FIELD SERVICE NOTE

F/S/N Number 140-040303-0
Date 1 OCT 1978

ATS-3 RETROFIT KIT

KIT-426

AX5175

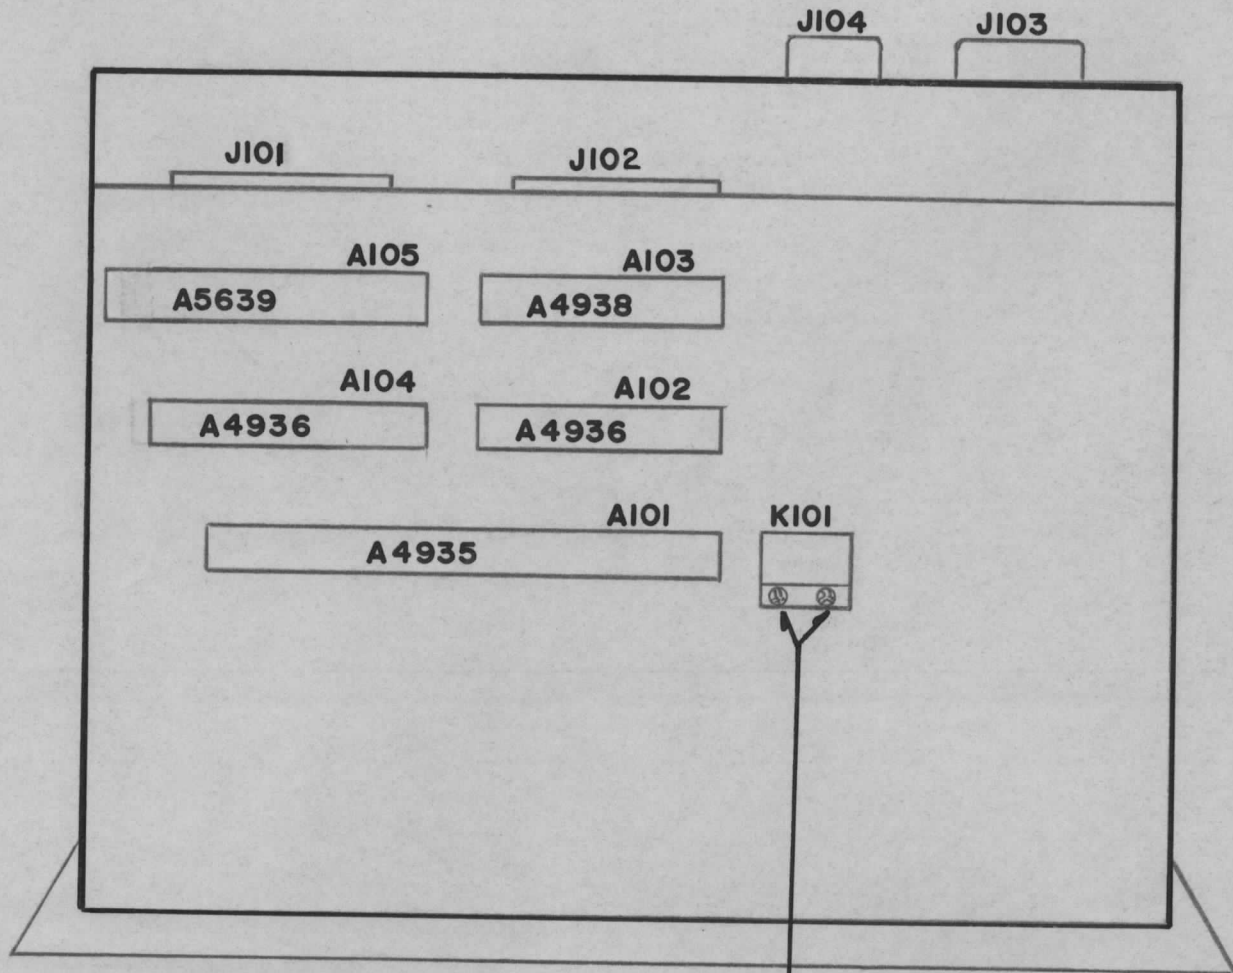
DRILL TWO(2) HOLES 5/32 DIA.
IN APPROX AREA FOR RELAY BRACKET
(MS6795)

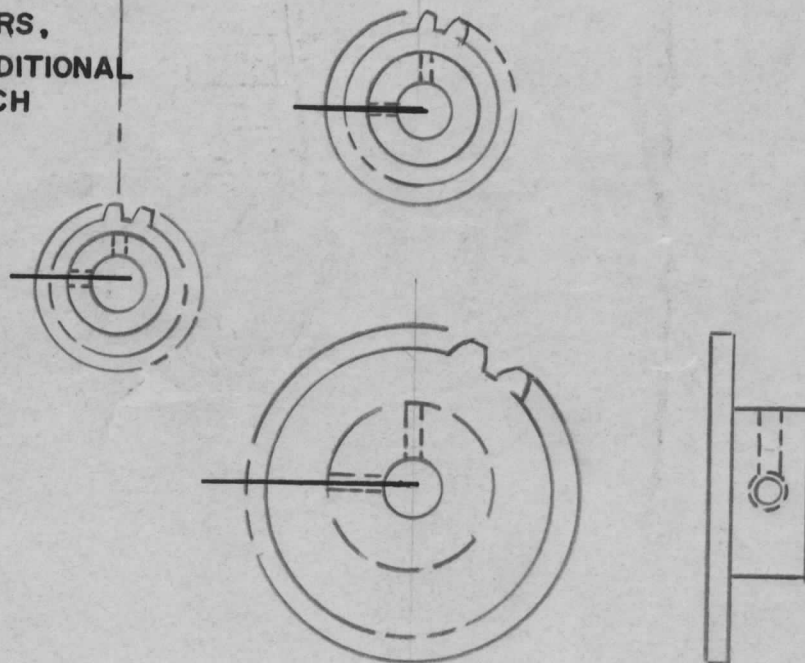
Items 37, 43 and 45 must be removed and holes must be drilled and taped for a second set screw. This set screw must seat 45° apart from the existing set screw.

REMOVE THREE (3) GEARS,
DRILL AND TAP ONE (1) ADDITIONAL
SET SCREW HOLE ON EACH

DETAIL "C"

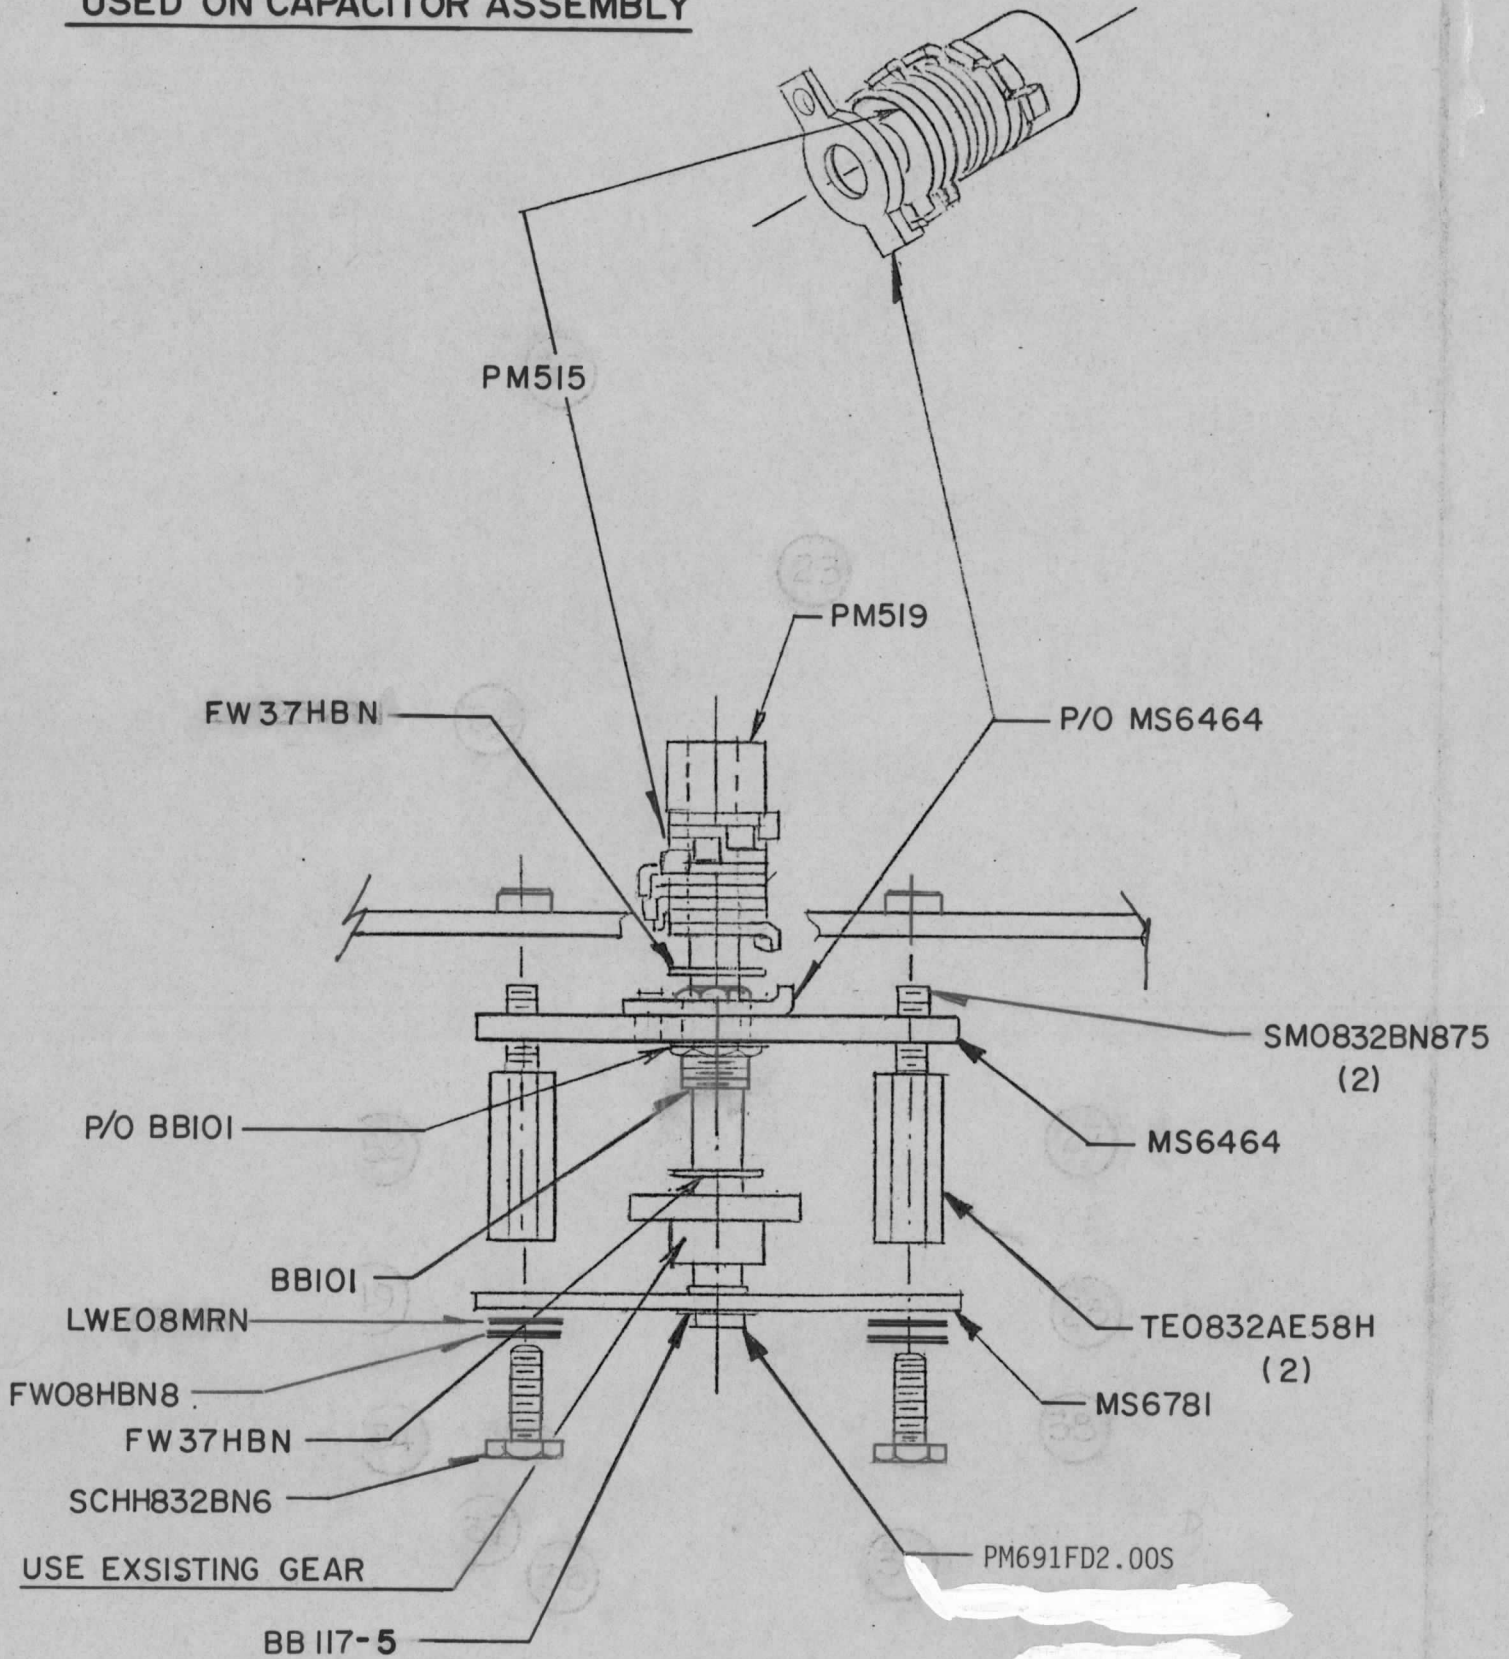
The gear stop assembly is to be assembled as per drawing AX5179 Detail "C". This assembly will seat in the vacated 1¼ inch hole and fastened via two threaded nuts which were left vacated with the removal of the 1K resistor (pot) assembly. (All parts **are** supplied)

When Detail "C" is seated correctly and tightened, align the three (3) gears, tighten six (6) set screws two per gear and seal.

AX5176 USED ON COIL ASSEMBLY

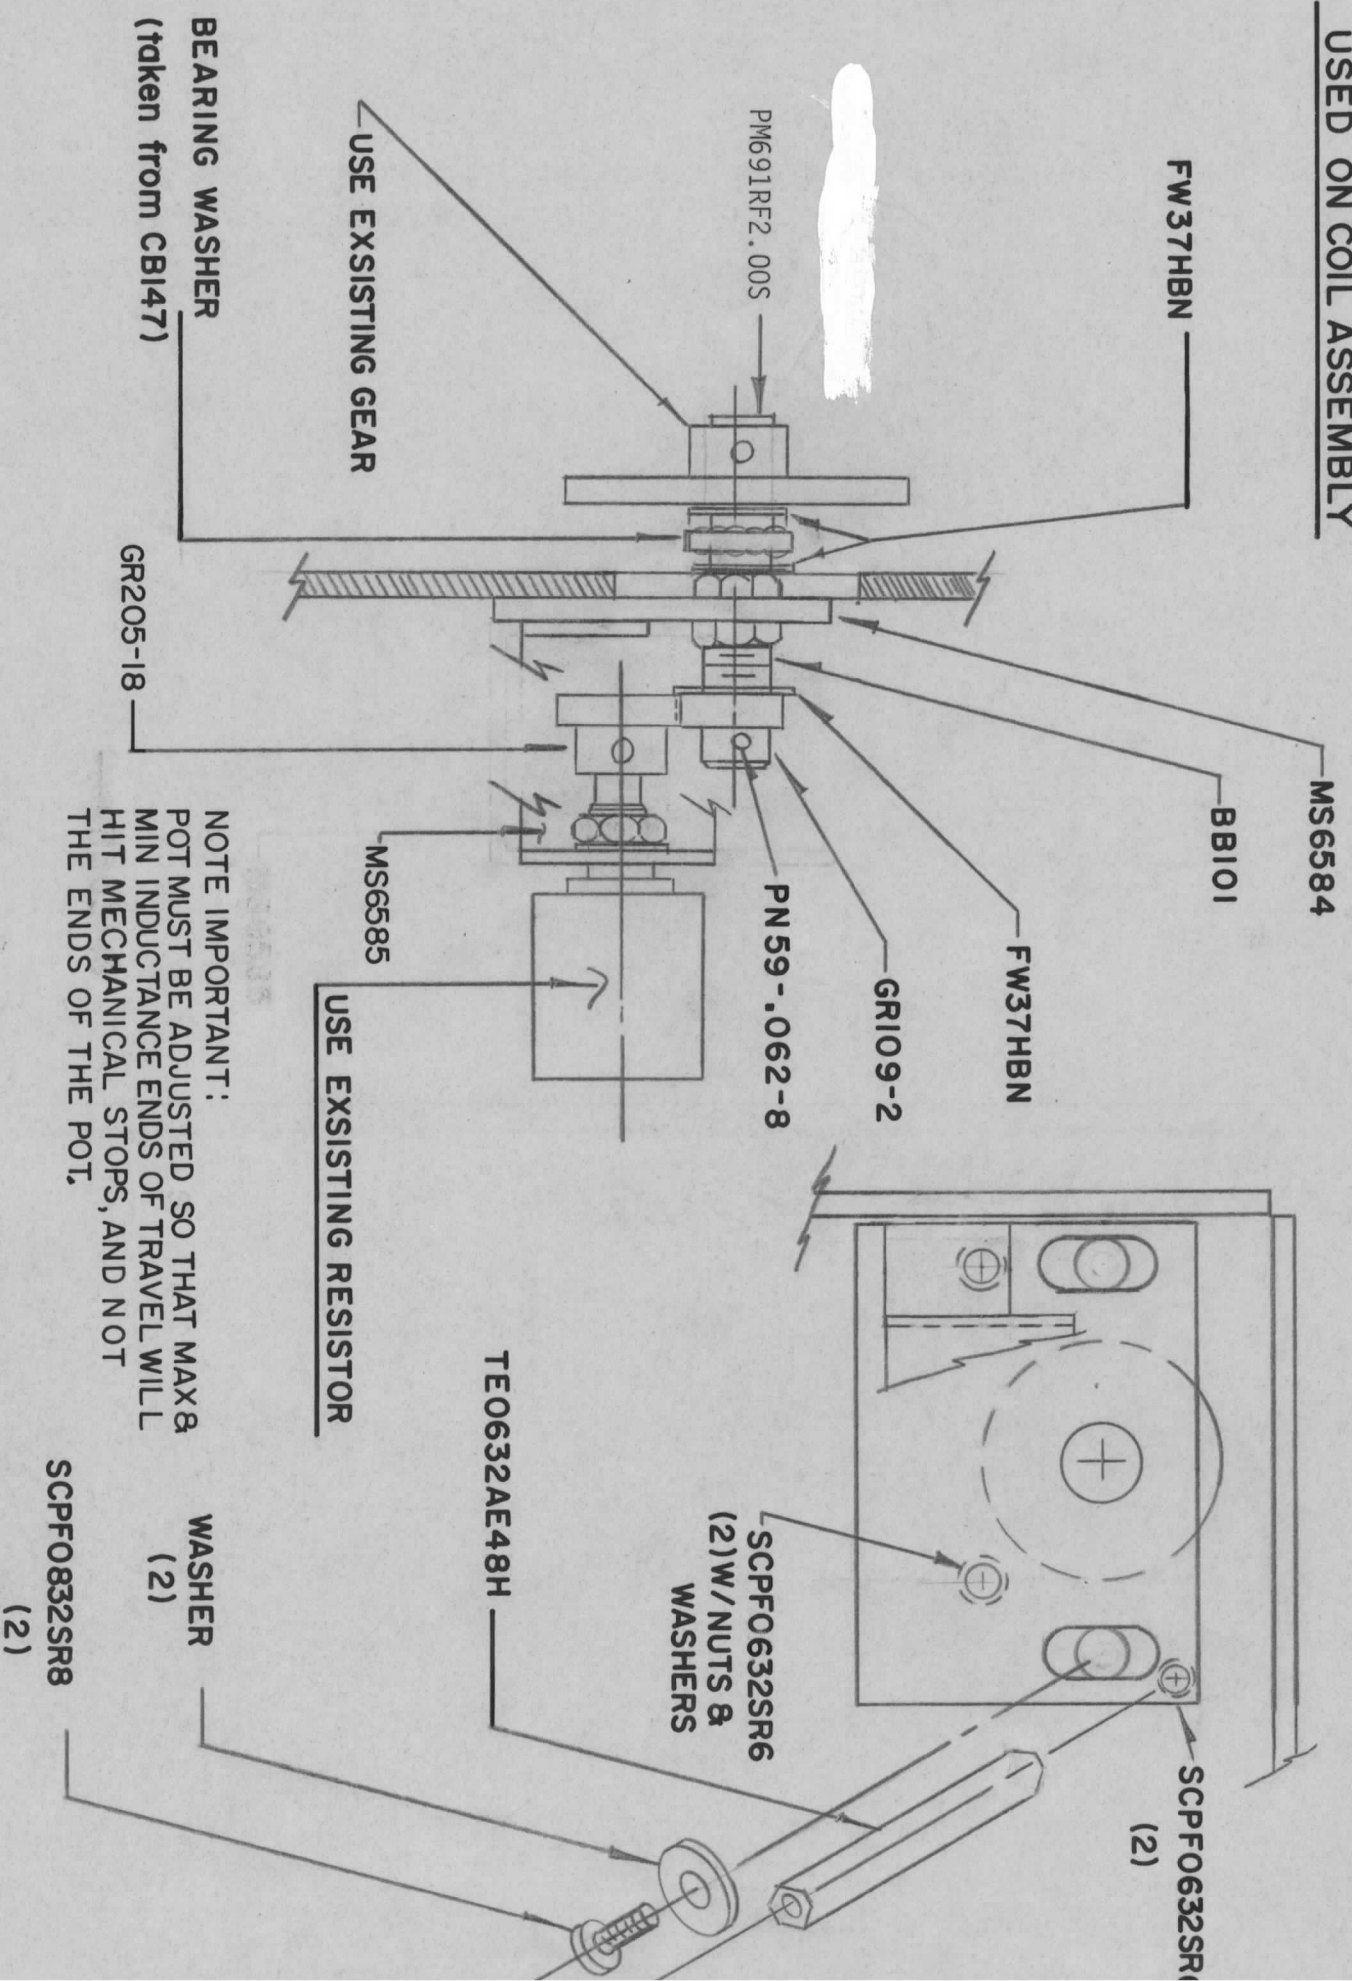
RV117-2-102 must now be re-assembled on MS6585, a detailed drawing of the entire assembly is supplied. Using AX5178, the parts supplied and the detailed drawing the assembly now can be completed and mounted in place. When the assembly is fastened securely, align the three (3) existing gears, tighten and seal with (Glyptal supplied).

DETAIL "D"

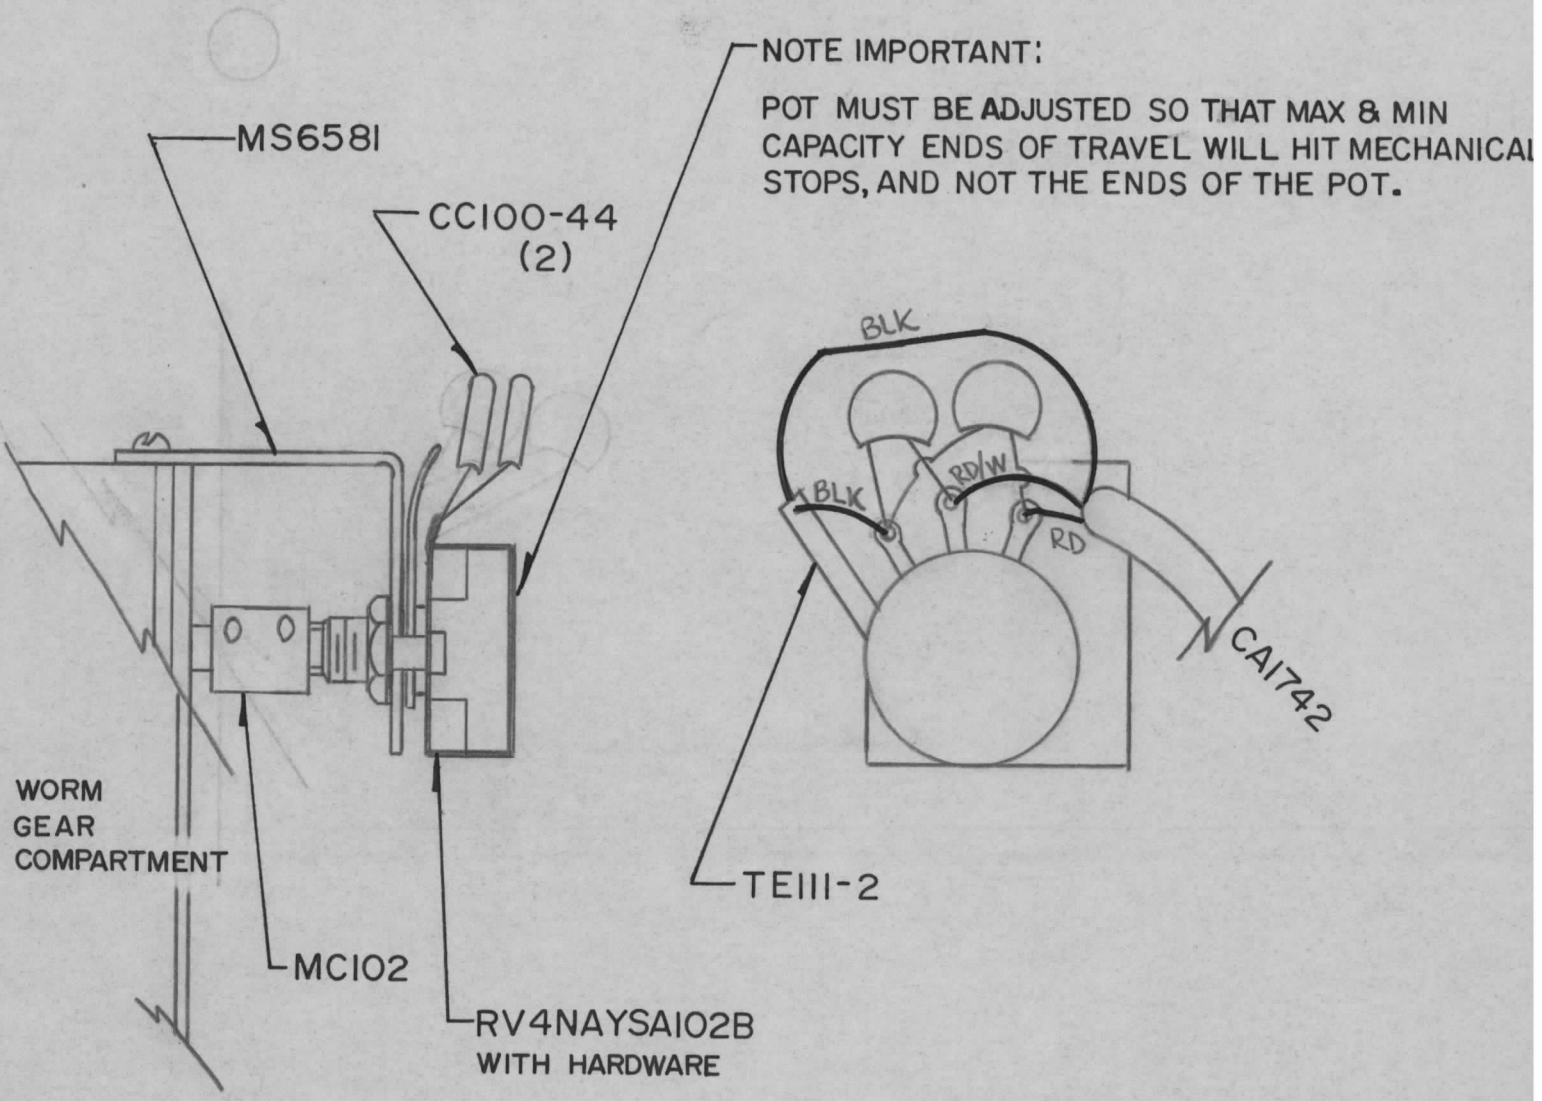
At the worm gear compartment, assemble a RV4NAYSA102 pot as per AX5179 Detail "D" (drawing and parts supplied)
